Kennecott Eagle Minerals

Re: File Number 08-52-0104-P, Humboldt Mill Joint Permit Application for an Inland Lakes and Streams Permit, Kennecott Eagle Minerals Company

In a letter dated January 7, 2009 a request for clarification/information was received from the Land and Water Management Division (LWMD) titled "Application Correction Request." In fulfillment of your request, please find attached, answers to your questions, additional engineering detail and supporting documentation.

FIGURE 2-4
HTDF PROPOSED FILL
CROSS SECTIONS B-B', C-C' AND D-D'

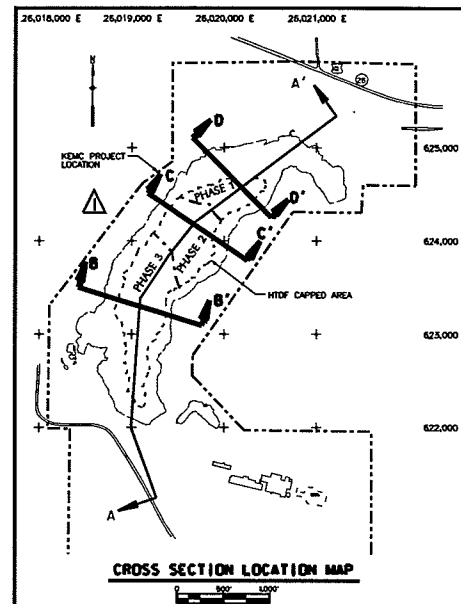
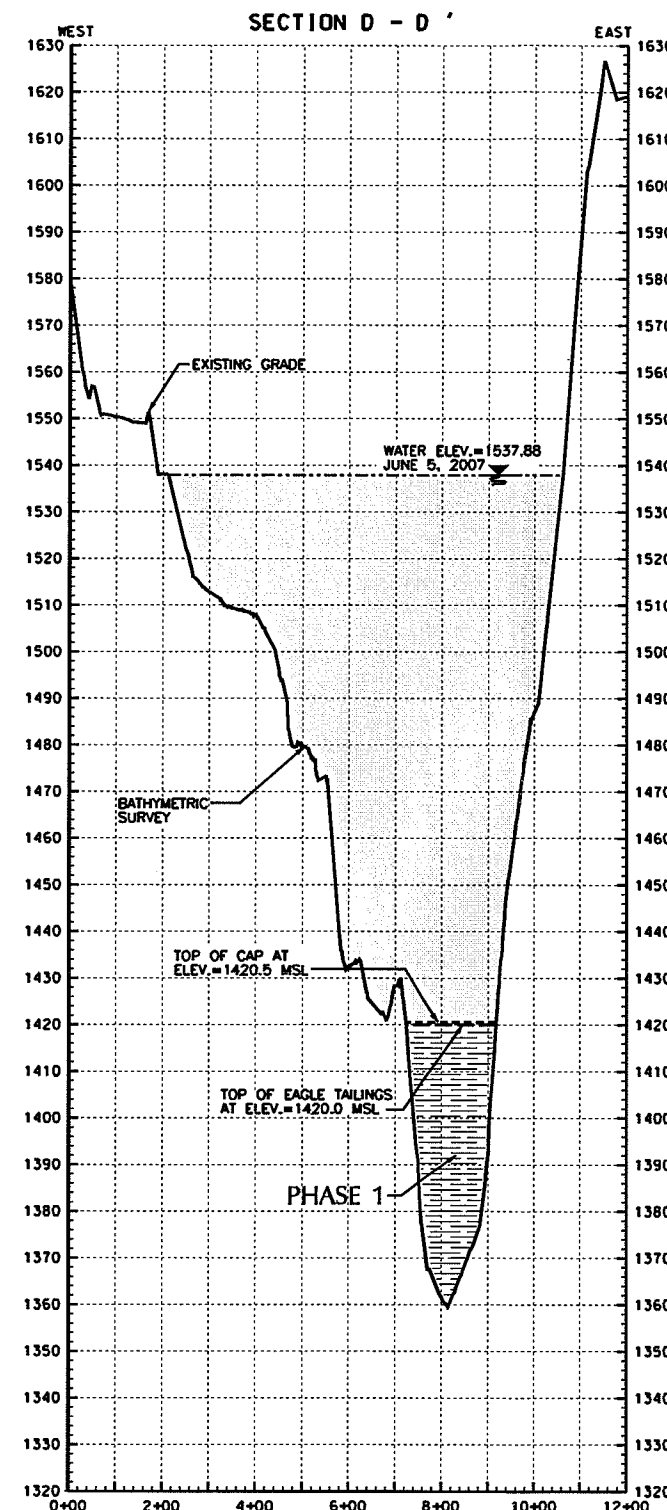
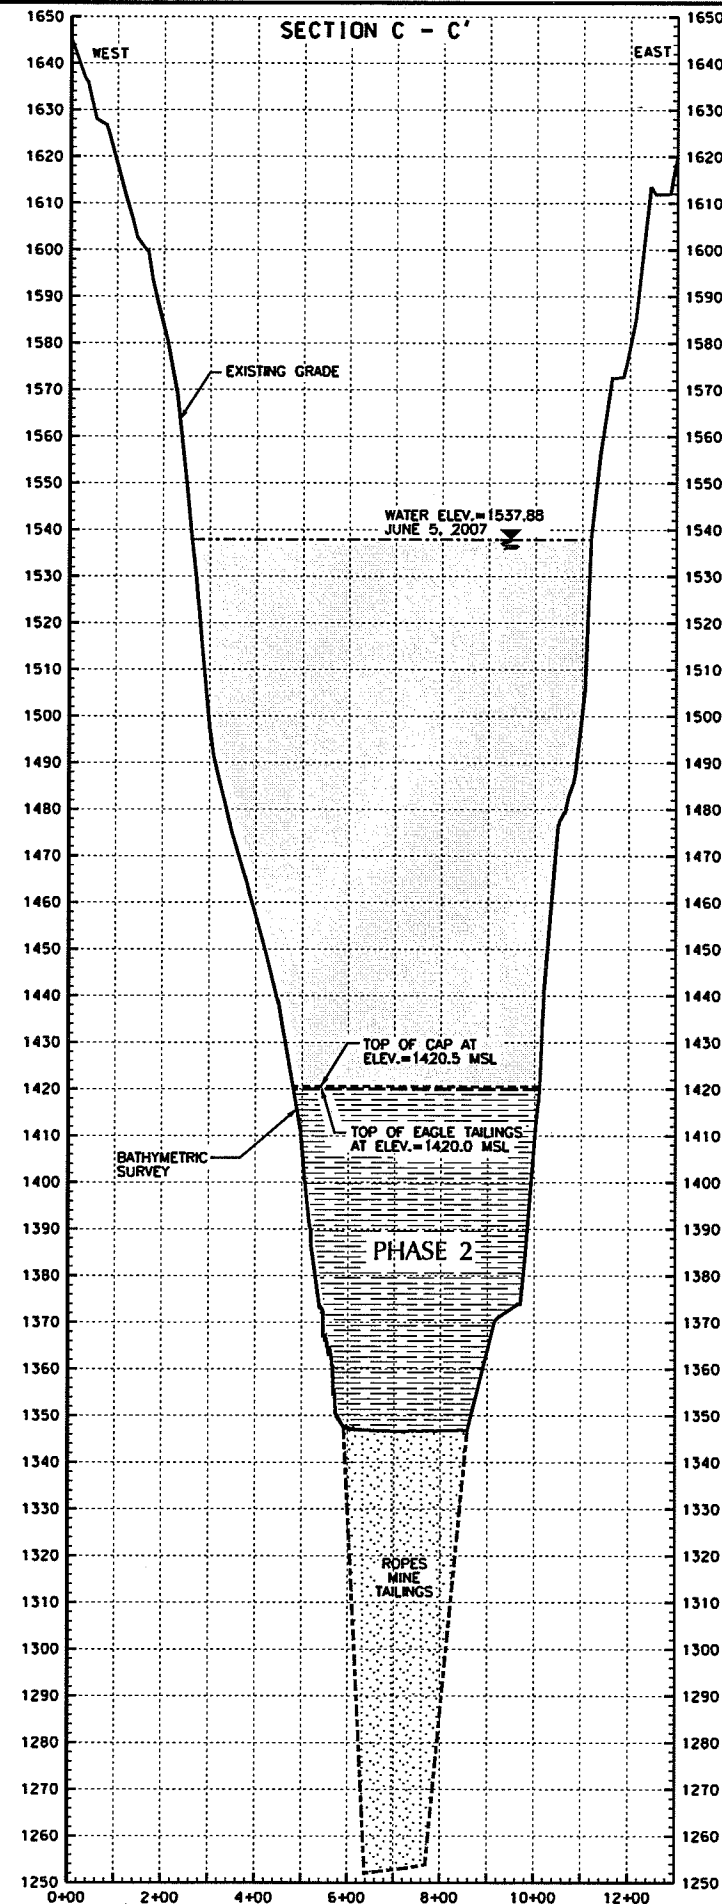
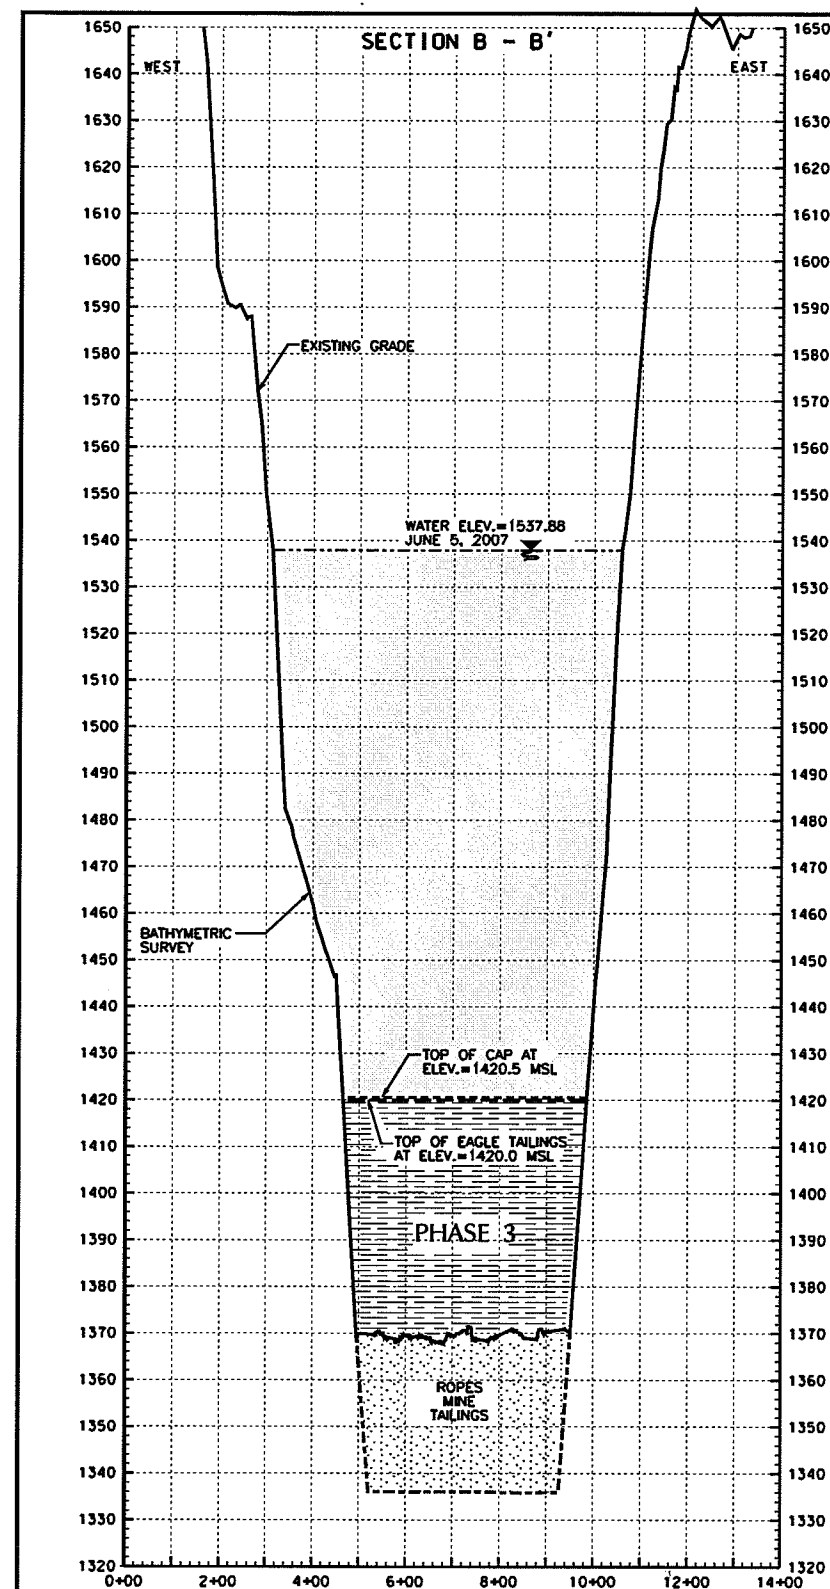
Figure 2-1 has been updated to include the surface area of the top of the tailings for each phase. Figures 2-3 and 2-4 now include a table with the following information regarding the proposed tailings fill for Sections A-A', B-B', C-C' and D-D':

4. Figure 2-3 and 2-4 location maps appear to have the phases reversed. Please clarify.

Updated Figures 2-3 and 2-4 are included in Attachment B for insertion into the permit application.

KEMC Response: *The insets for both figures had the labels for Phases 1 and 3 reversed. Those figures have been revised and copies of Figures 2-3 and 2-4 are contained within Attachment B.*

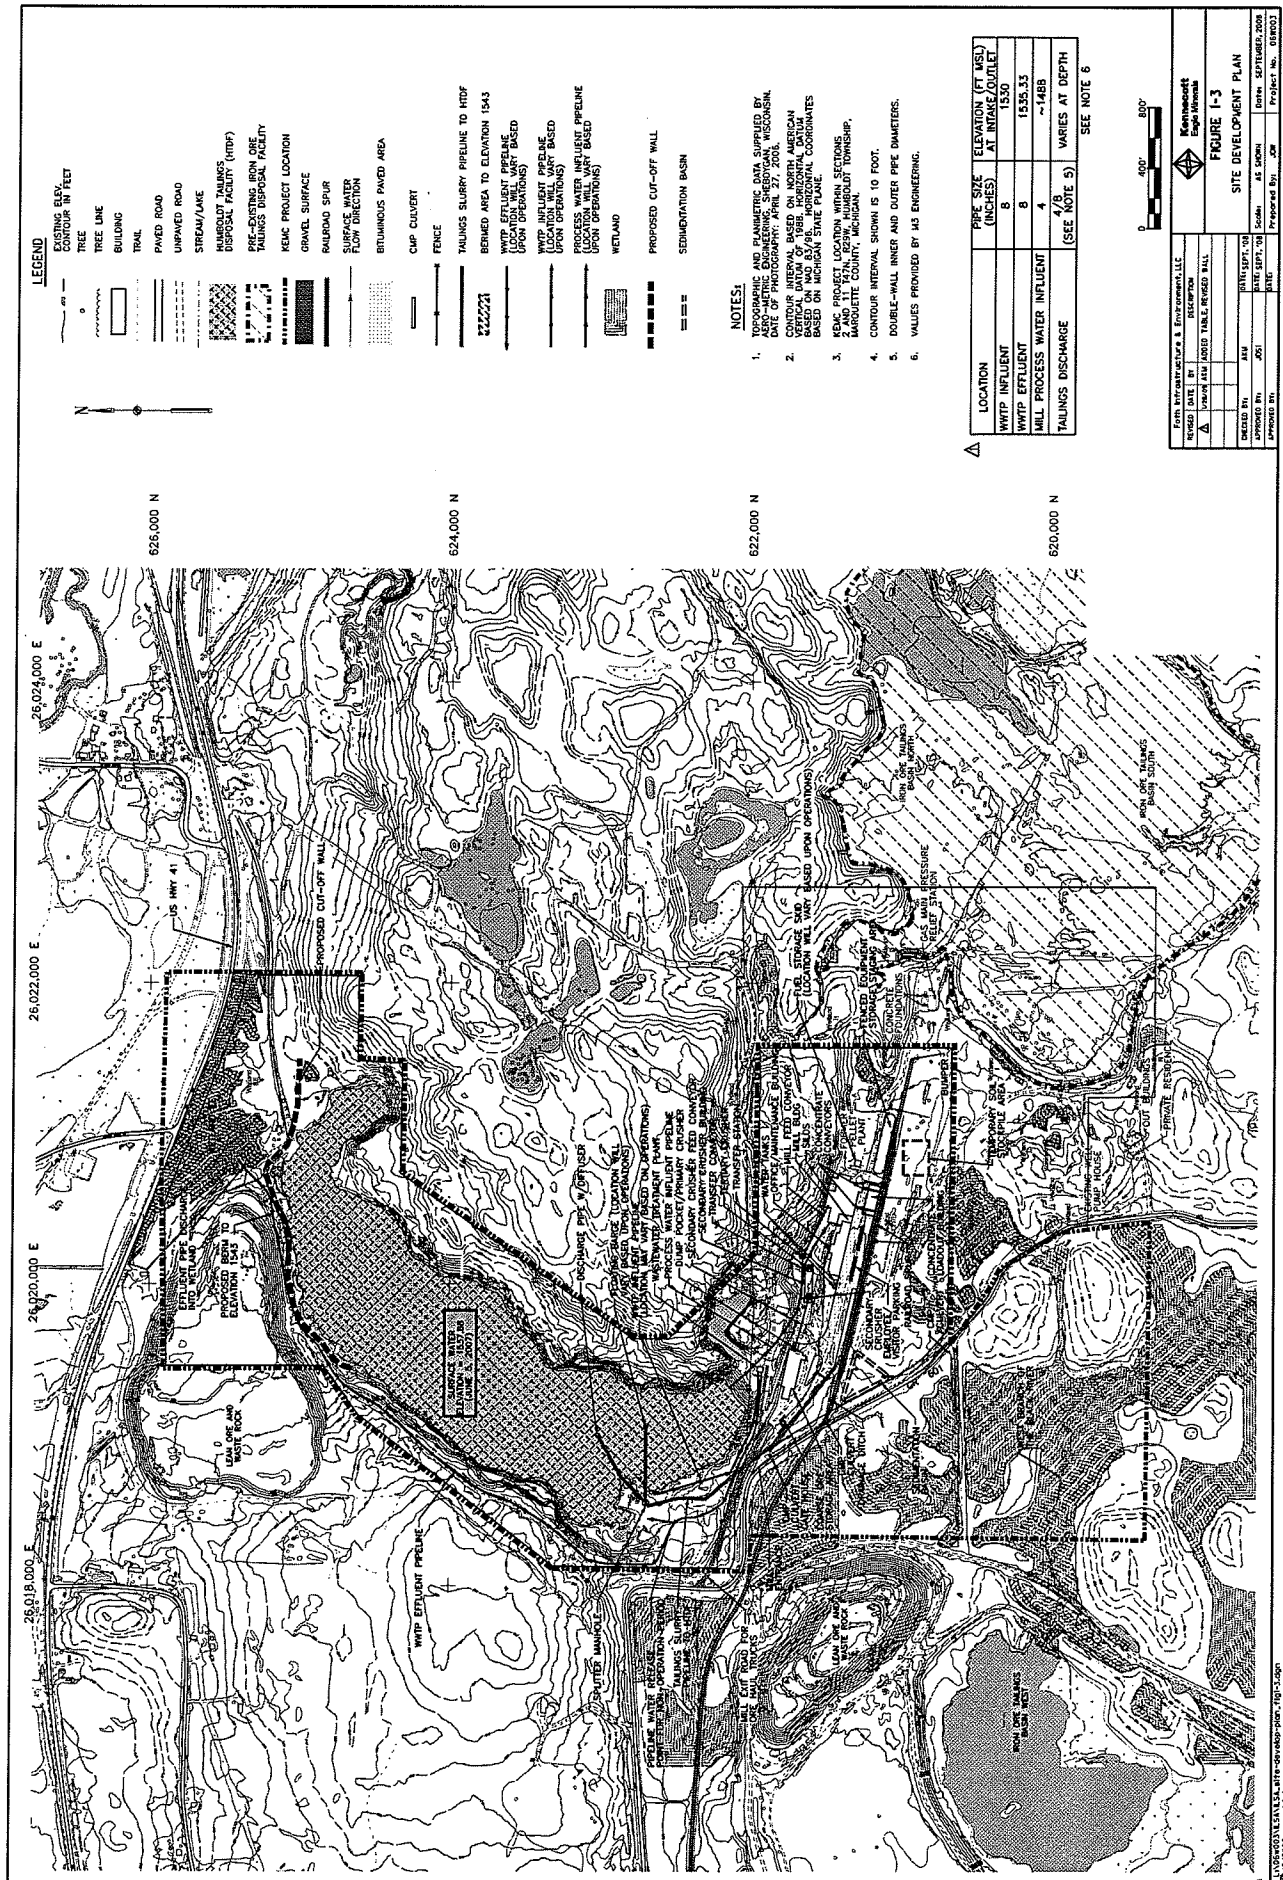
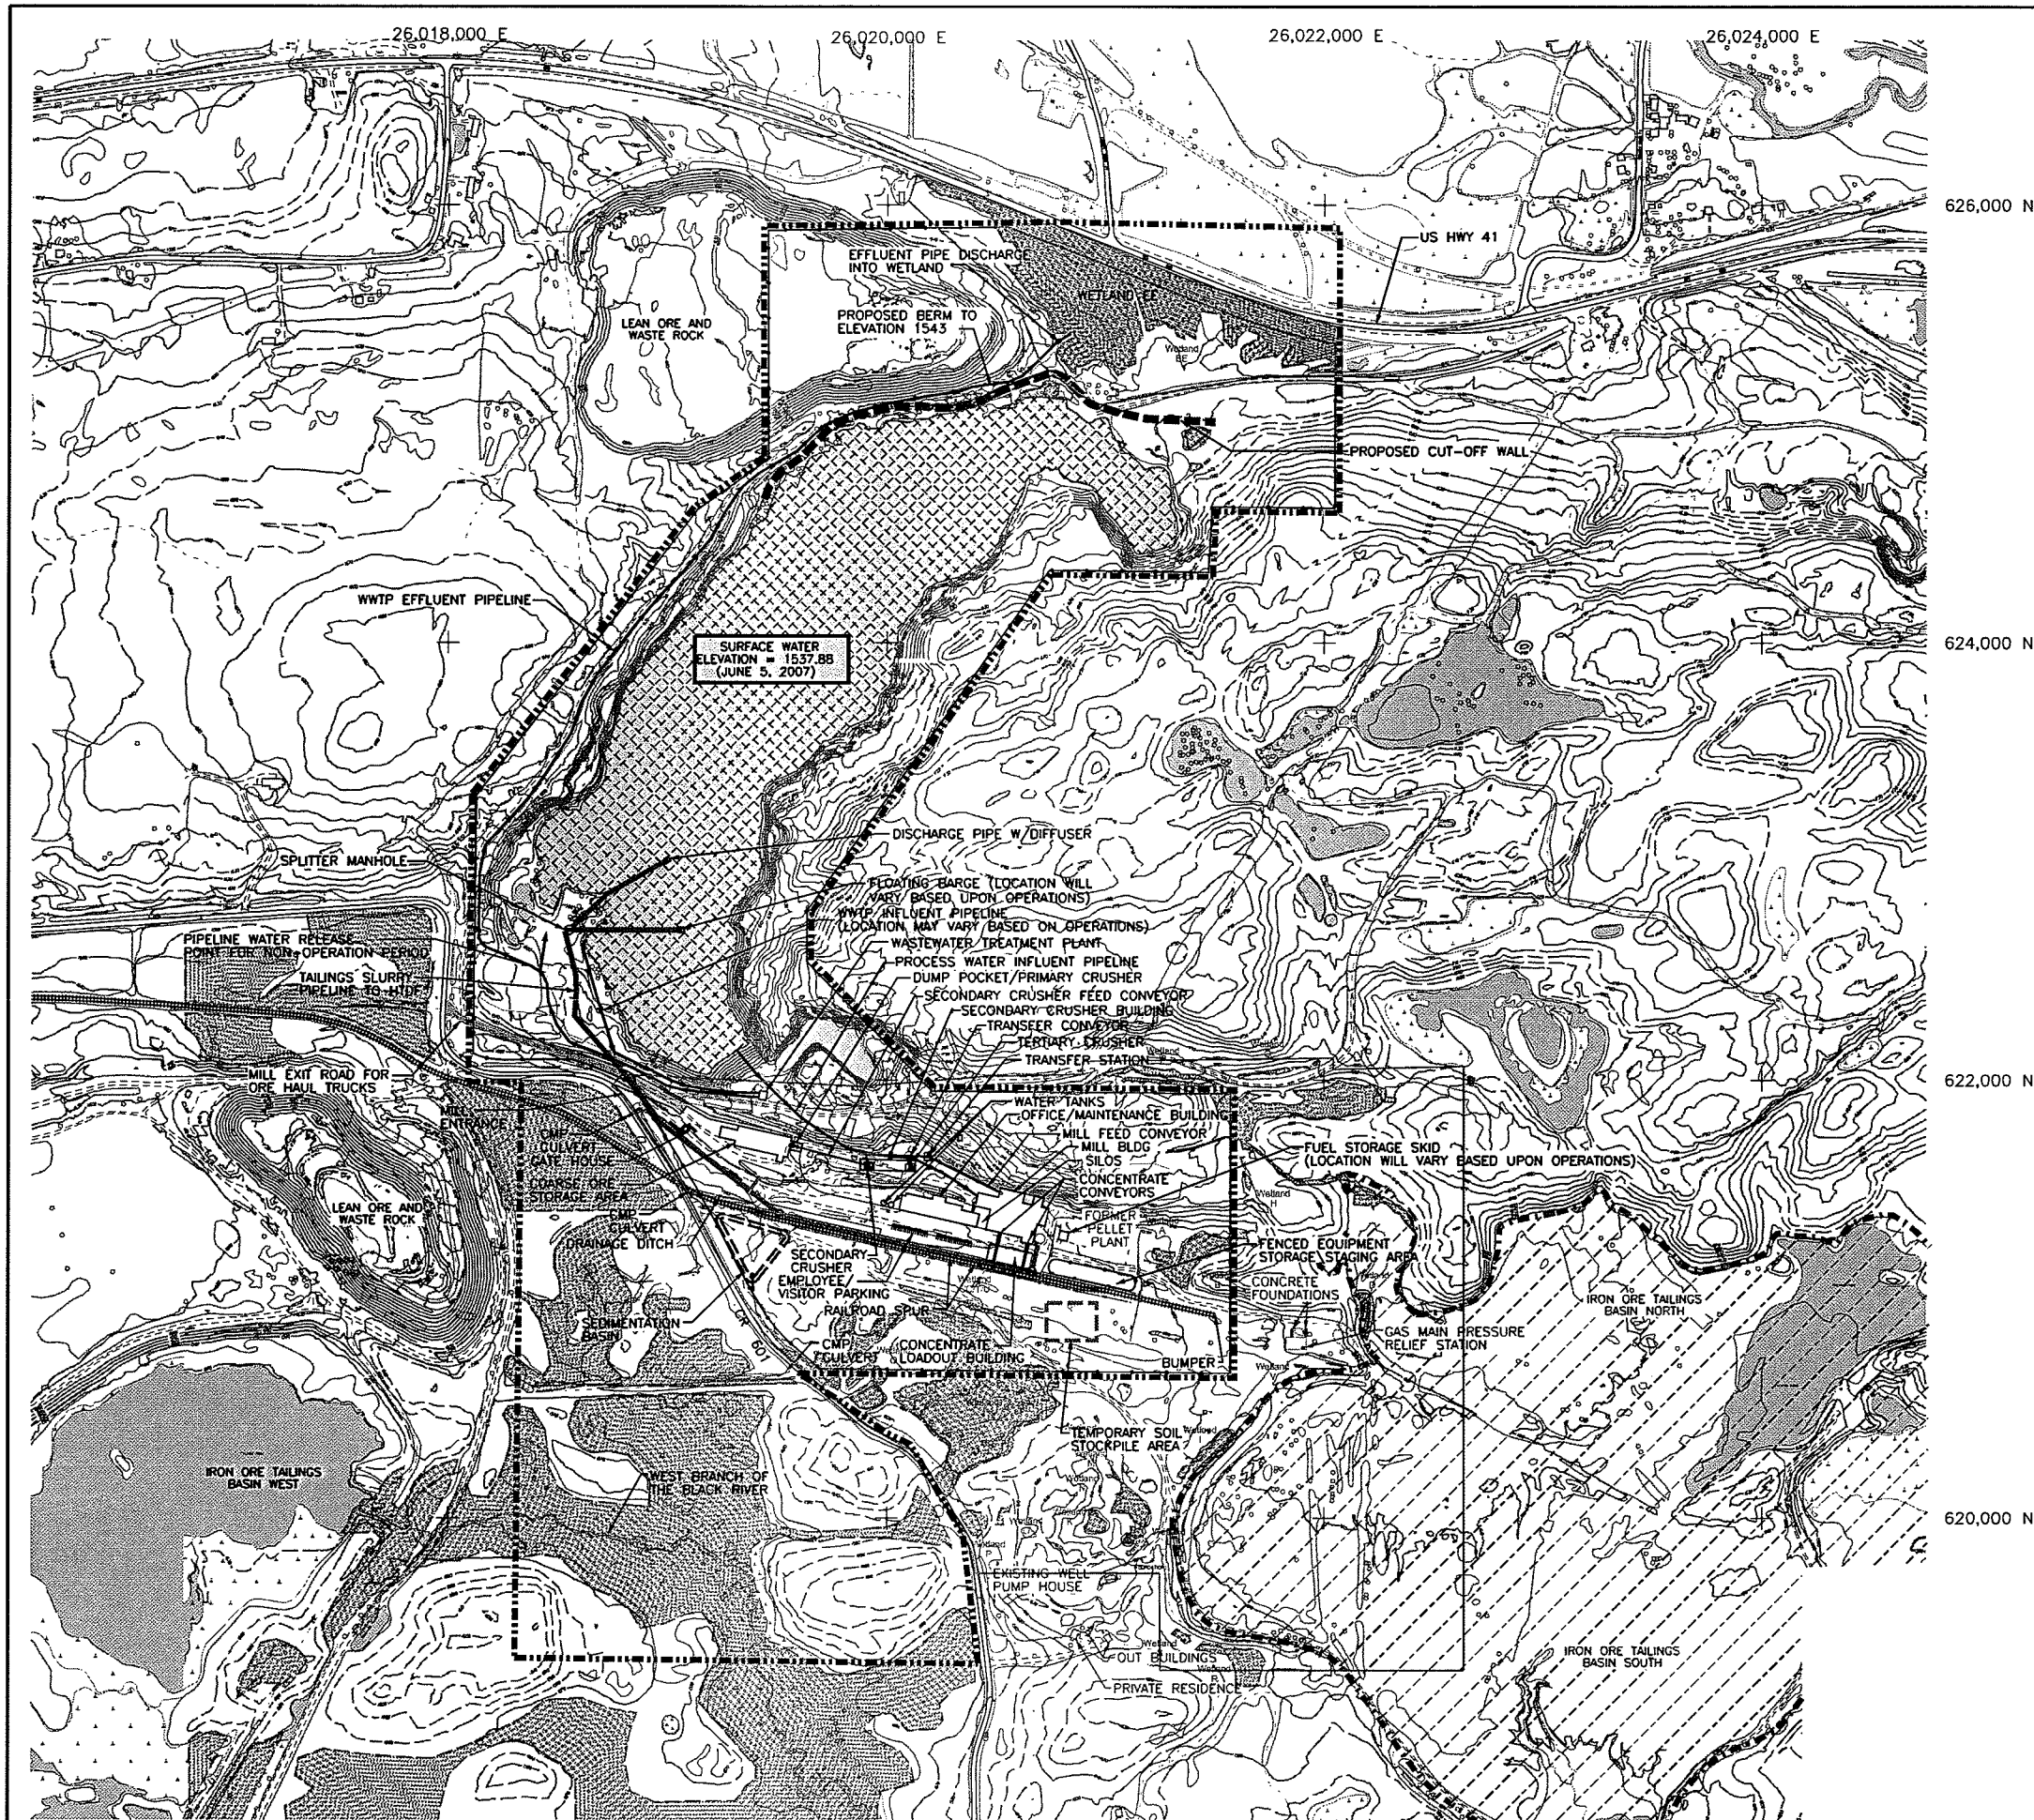
2. Provide the pipe diameters and invert elevations in Section 10J

3. Provide a legible black and white 8 ½ x 11 copy of Figure 1-3 for public notice purposes.

There was not enough space within section 10J to include the pipe diameters and elevations for all four intake and outlet pipes. This information has been included on Figures 1-3, 2-1 and 2-5 (Attachment C).

KEMC Response: A black and white 8 ½ x 11 copy of the revised Figure 1-3 is included within Attachment C.
